Village of Mukwonago
PLAN COMMISSION MEETING
Notice of Meeting and Agenda
Tuesday, June 11, 2019

Date: June 5, 2019

From: Tim Schwecke, AICP; Interim Village Planner

Subject: Malcom Drilling Site Plan / Architectural Review

OVERALL LANDSCAPE PLAN

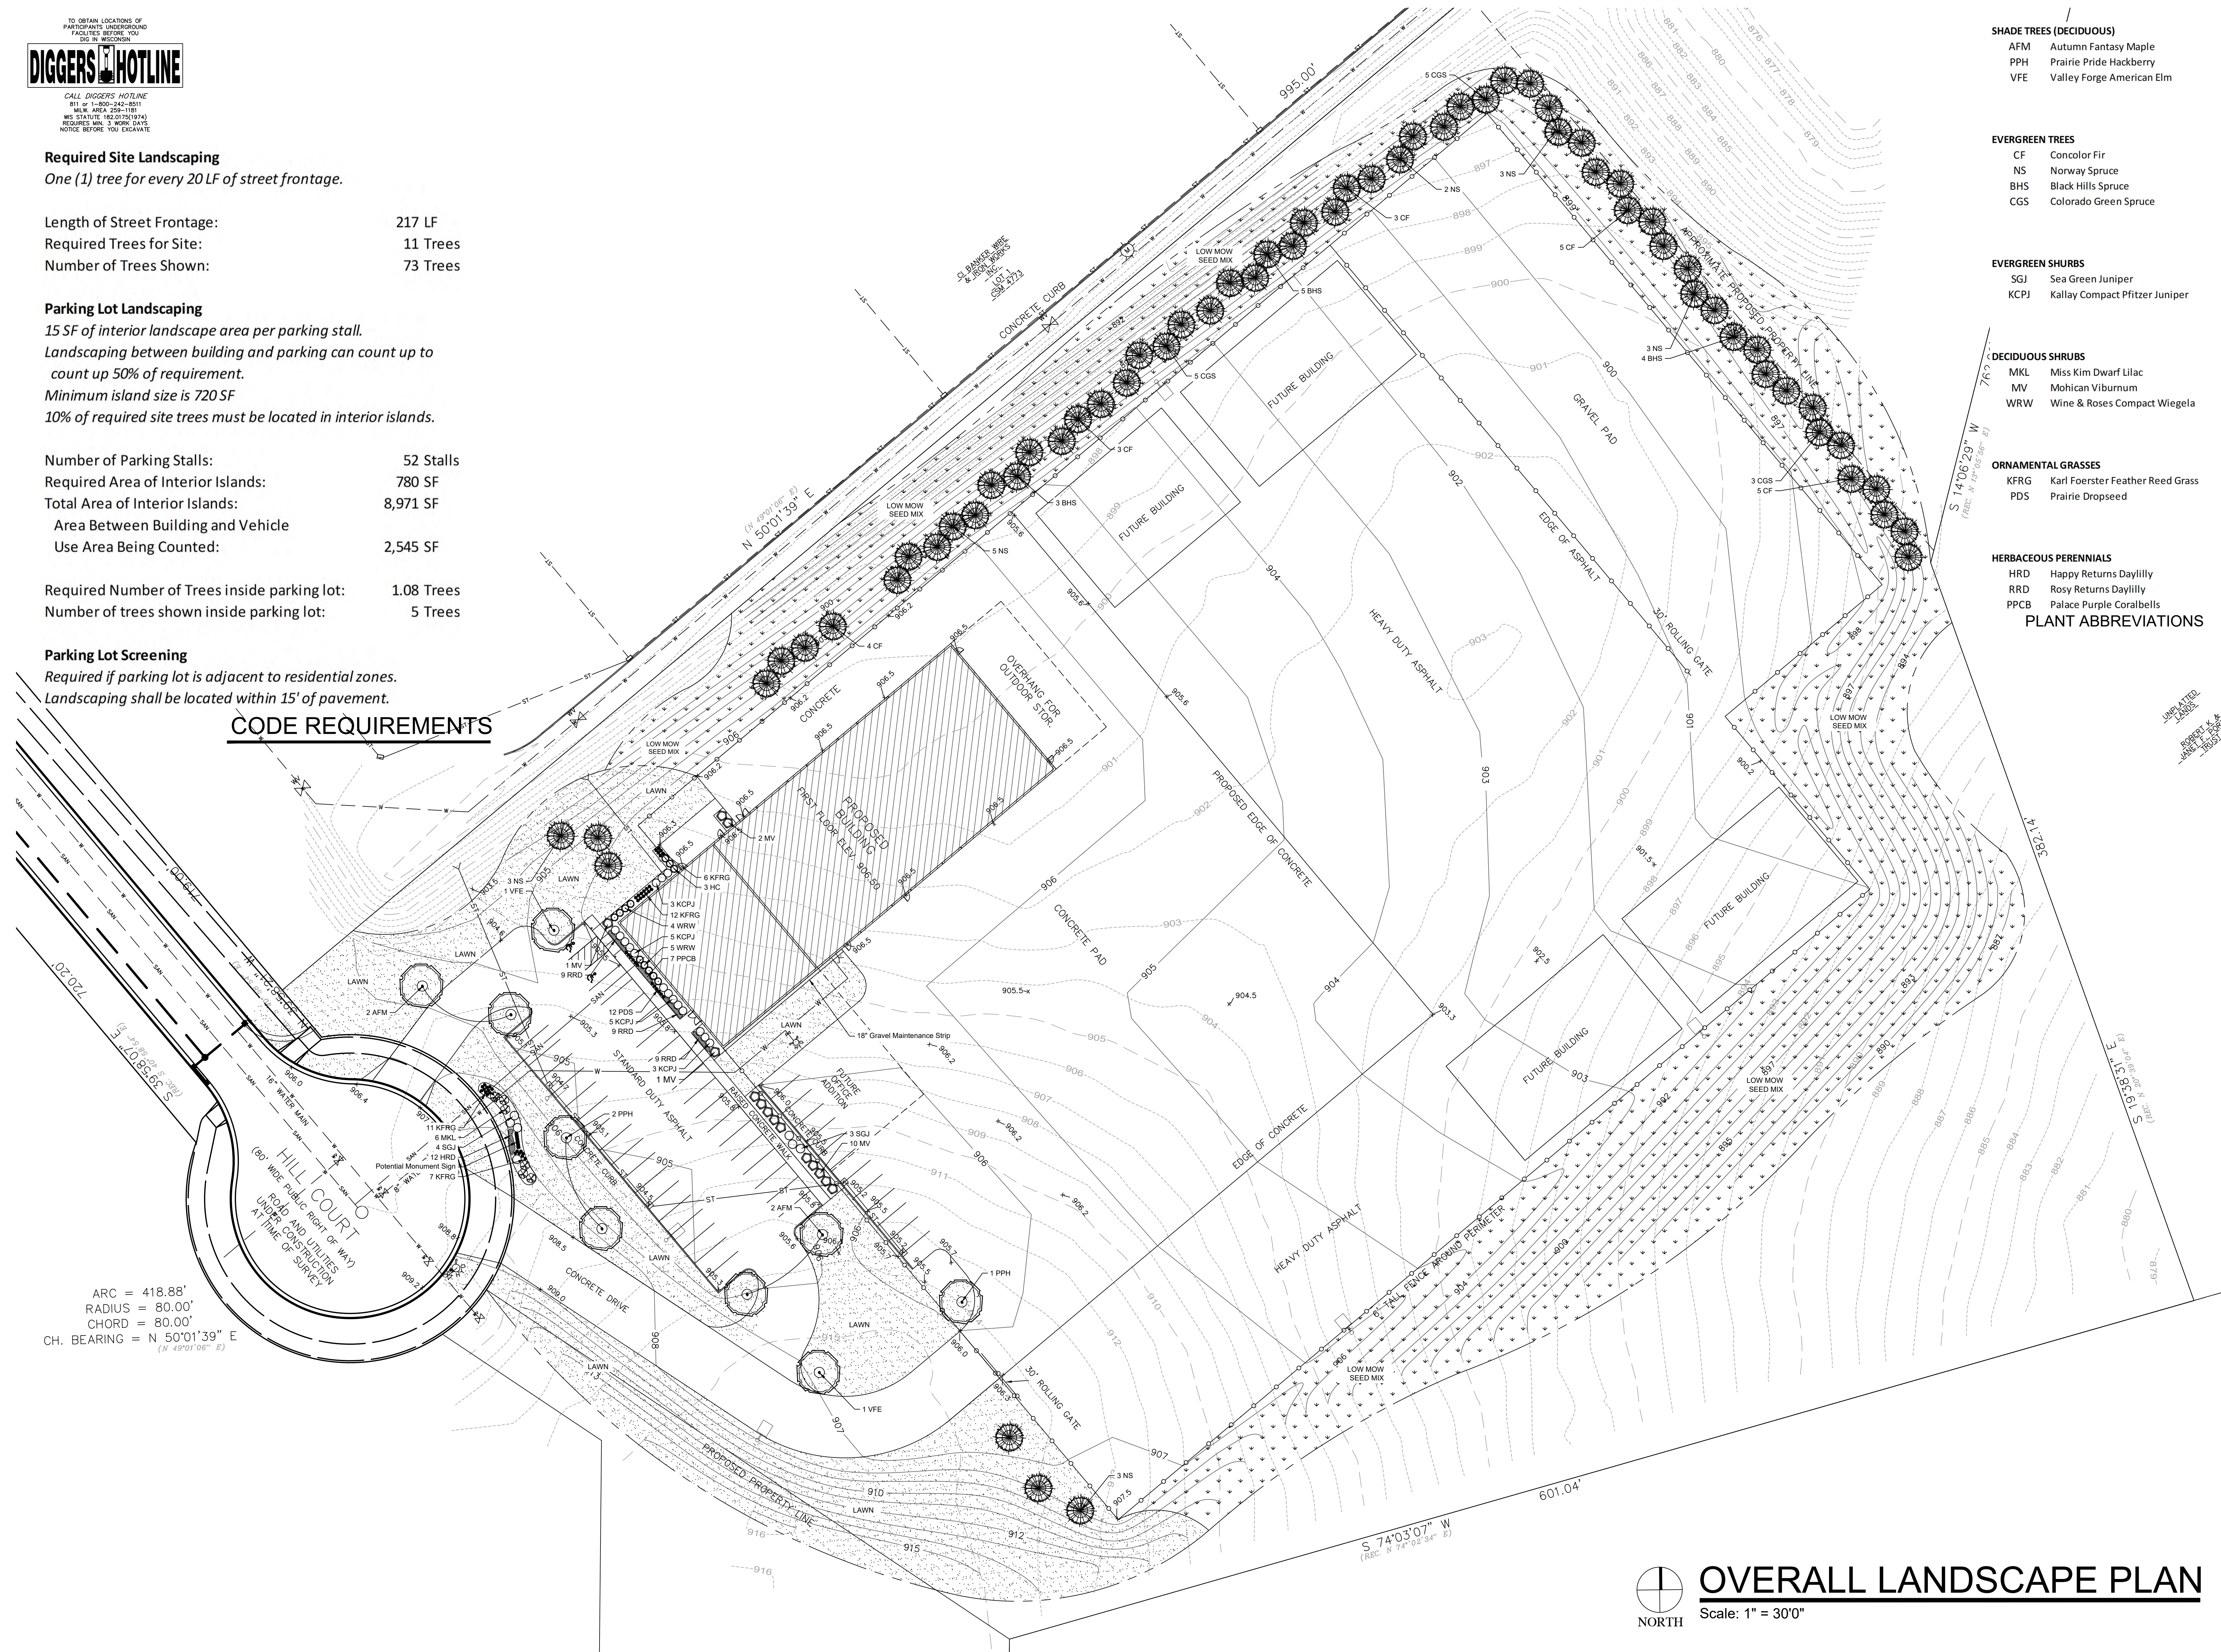
Landscaping plan Staff has reviewed the landscaping plan and has determined it complies with the landscaping requirements. It should be noted the plans call for a significant vegetative screening with conifers along the north north/east lot lines. In earlier reviews the previous Village Planner, stated that a berm would be required along the northeast lot line. That has not been addressed. The Plan Commission will need to determine if a berm is needed to provide additional screening of the site.
